HISTORIC PRESERVATION BOARD

HISTORIC PRESERVATION BOARD MEETING

**STAFF MEMORANDUM
HISTORIC PRESERVATION PROGRAM
PLANNING AND URBAN DEVELOPMENT**

TO: Chair Pollard and Members of the Historic Preservation Board
FROM: Rob Wiener, Historic Preservation Compliance Coordinator
DATE: October 14, 2022
RE: 99 Capisic Street, Addition and New Garage / Guest House - PUBLIC HEARING
PROJECT ID: HPBR-002024-2022
MEETING: October 19, 2022

A2-00	EXTERIOR ELEVATIONS: SOUTH		ISSUED FOR HP BOARD REVIEW NOT FOR CONSTRUCTION	OCTOBER 19, 2022	STUDIO E P. O. B. O. X. 1 3 2 8 5 WESTBROOK, ME 04098 9 0 6 - 6 7 4 - 1 0 3 3
	CARMONA BARN				
	99 CAPISIC STREET, PORTLAND, ME

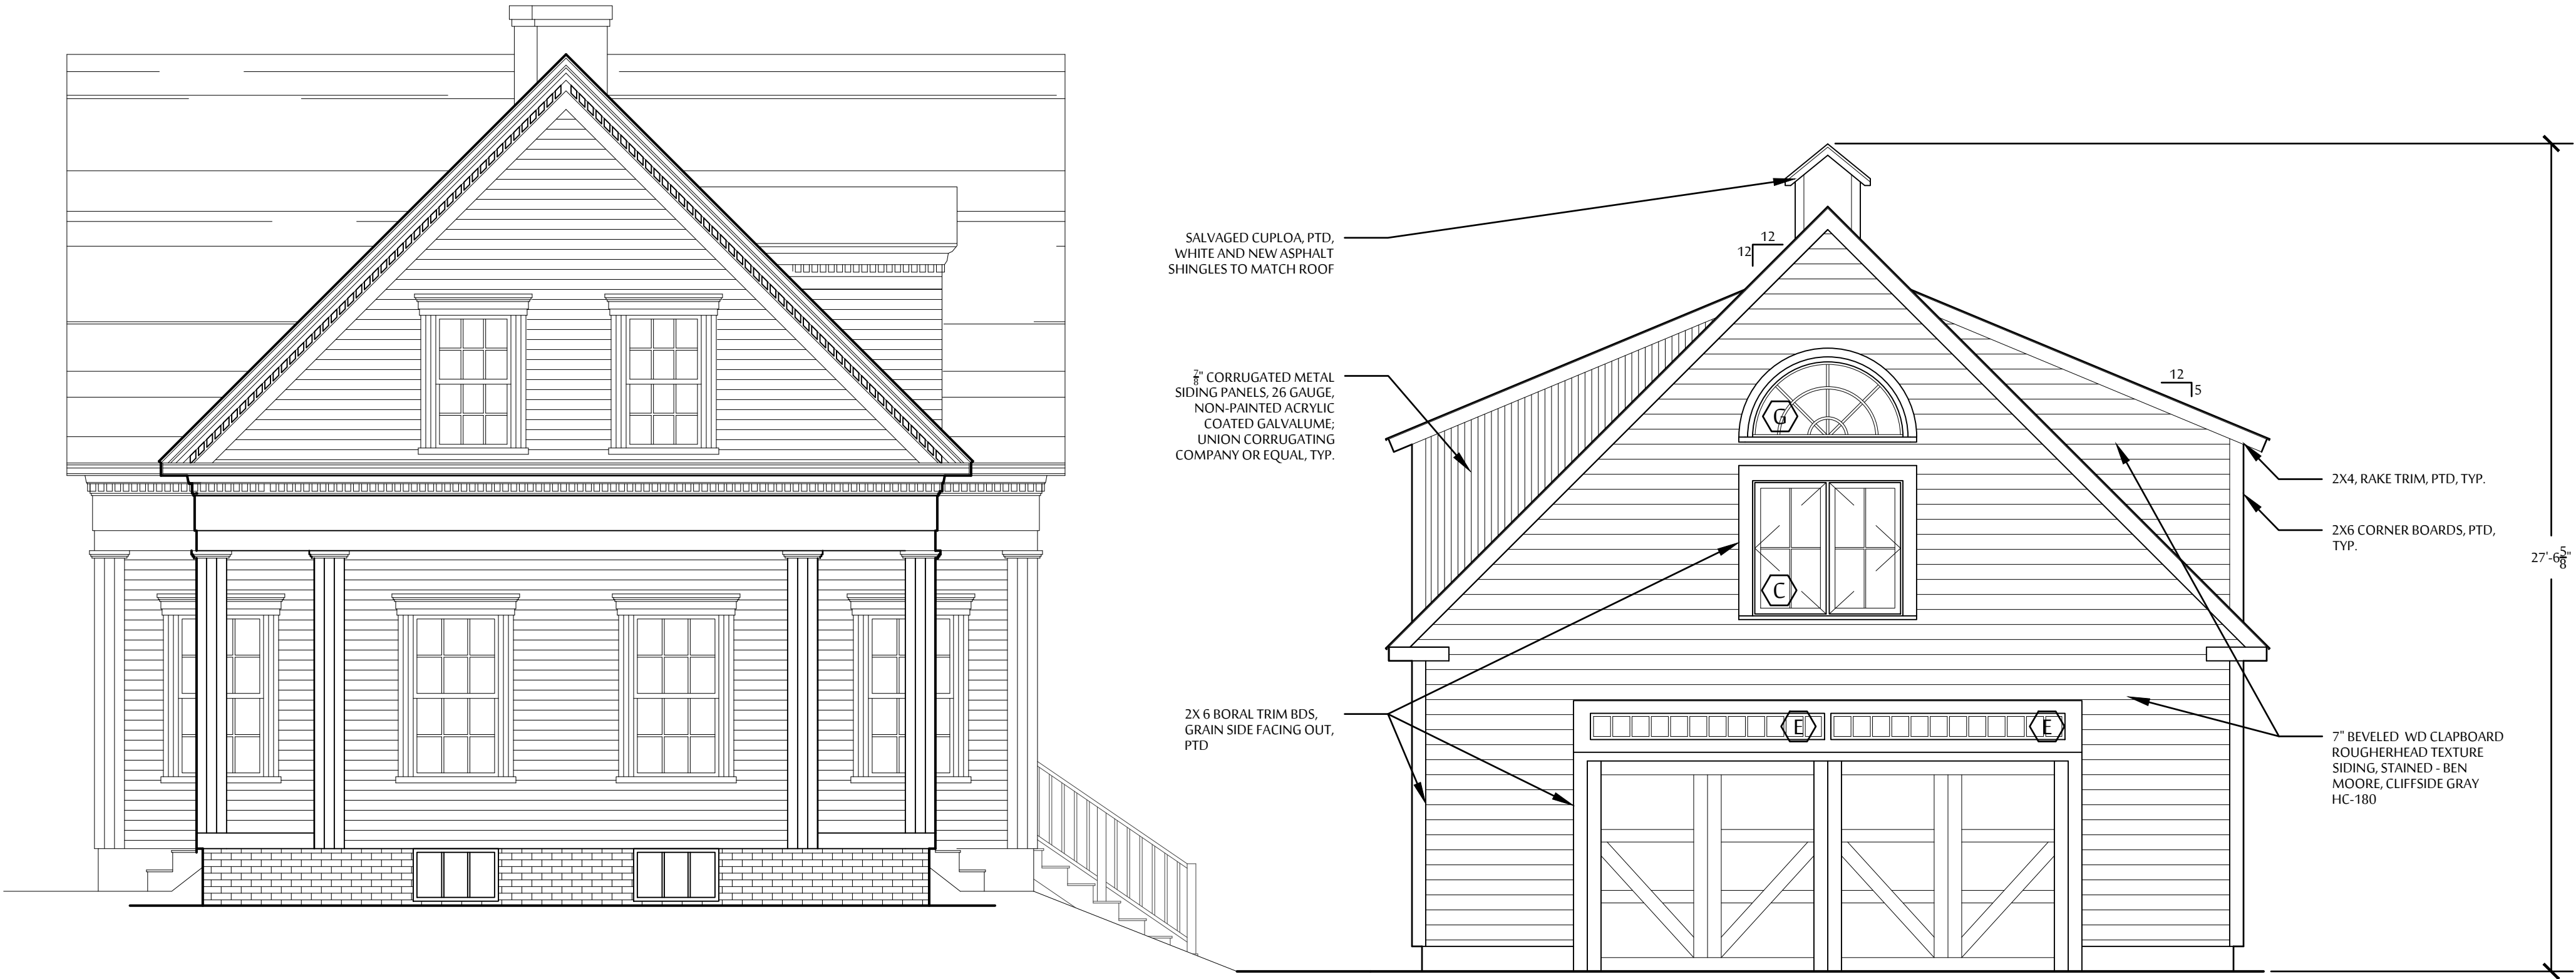
Staff believes the final design presented for the October 19 hearing is a more refined, compatible, recessive, and successful design. The applicants met with staff after the August 3 meeting, and have made a number of changes suggested by the Board at the first hearing. On the front (south) façade of the barn, staff notes:

- Lowering the eaves and overall height, and narrowing the overhangs on the barn have all improved the relationship to the primary house.
- Proposed plans show the metal siding on one dormer side (the south end of the west dormer.) The owner would like to add this contemporary accent to the front face, but if the Board finds it looks out of place and undermines the unity, restraint, balance, and quiet of the composition, members could include a condition requiring its elimination.

Landmarks appreciates staff's comments and agrees that the revised design is much more compatible with the existing house and that complements it well as a modern intervention that is not attempting to present itself as historic. We also agree with staff that the varied use of metal on the front elevation of the barn creates confusion and that a simpler use of a singular material will be more successful. Therefore, we support staff's recommendation to approve this application, with the condition to switch the metal siding on the front façade with wood to match the rest of that exterior.

- 1) Substitute wood siding for the proposed metal siding on the south (front-facing) end of the west dormer.

A2-01		EXTERIOR ELEVATIONS: EAST & WEST		ISSUED FOR HP BOARD REVIEW NOT FOR CONSTRUCTION		STUDIO E P. O. B O X. 1 2 8 5 WESTBROOK, ME 04098 6 0 3 - 6 7 4 - 1 2 8 5	
		CARMONA BARN		99 CAPISEC STREET, PORTLAND, ME

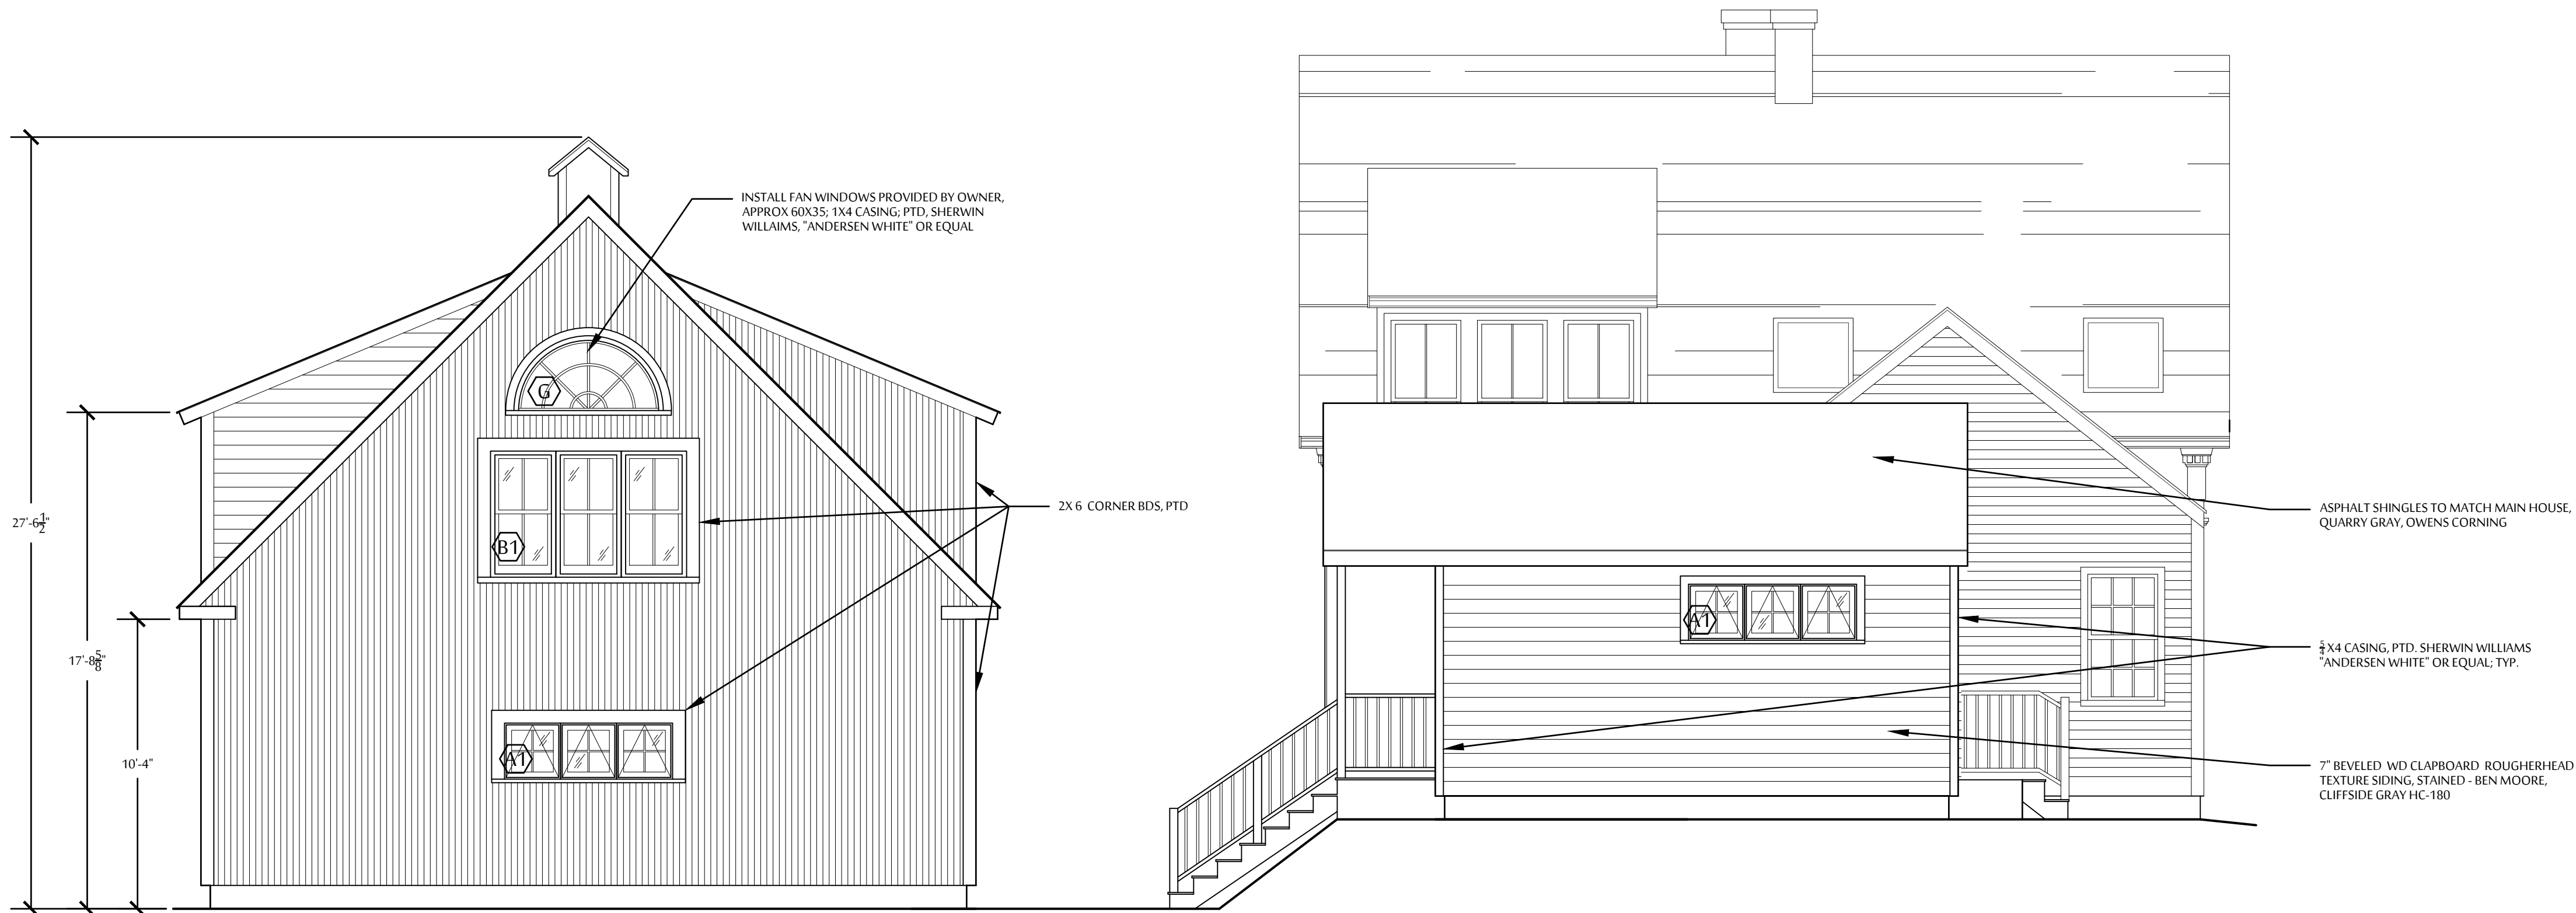
On the east dormer, staff agrees with the changes to the windows, with two pairs of casements that are taller than before, giving them more vertical proportions. Based on the owner's and the architect's responses to Board concerns, staff is recommending approval of the proposed design on October 19. As a new accessory structure that is located toward the back of the property, staff finds the barn to be appropriately deferential to the historic house and meeting the Standards for New Construction. Staff also believes that the addition to the rear of the house meets the Standards for Alterations.
